February 16, 1987

Service Bulletin No. 477A
(Supersedes Service Bulletin No. 477)
Engineering Aspects are
FAA Approved

Inspection and Rework of P/N LW-18790 Rocker Arm Assembly

Figure 1. P/N LW-18790 Rocker Arm Assembly Showing Area for Measuring Wall Thickness

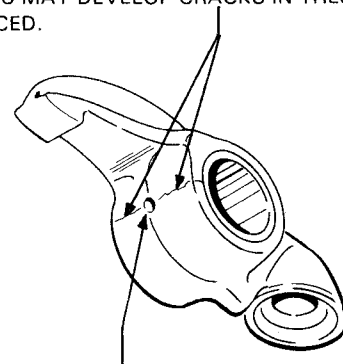
P/N LW-18790 ROCKER ARMS WITH LESS THAN .075 INCH WALL THICKNESS MAY DEVELOP CRACKS IN THESE AREAS AND MUST BE REPLACED.

MEASURE ROCKER ARM OUTER EDGE WALL THICKNESS AT THINNEST POINT WITHIN THIS AREA. BOTH SIDES OF ROCKER ARM.

3. Measure the wall thickness of the outer edge of the bushing bore boss in the area shown in Figure 1. If a ball-type micrometer or similar method is used to measure the combined thickness of the rocker arm wall and bushing, subtract .062 inch from the total measurement (.062 inch equals the bushing wall thickness).

4. Replace any P/N LW-18790 rocker arm that does not have at least a .075 inch wall thickness at the thinnest point within the 90° area, on both sides, as shown in Figure 1.
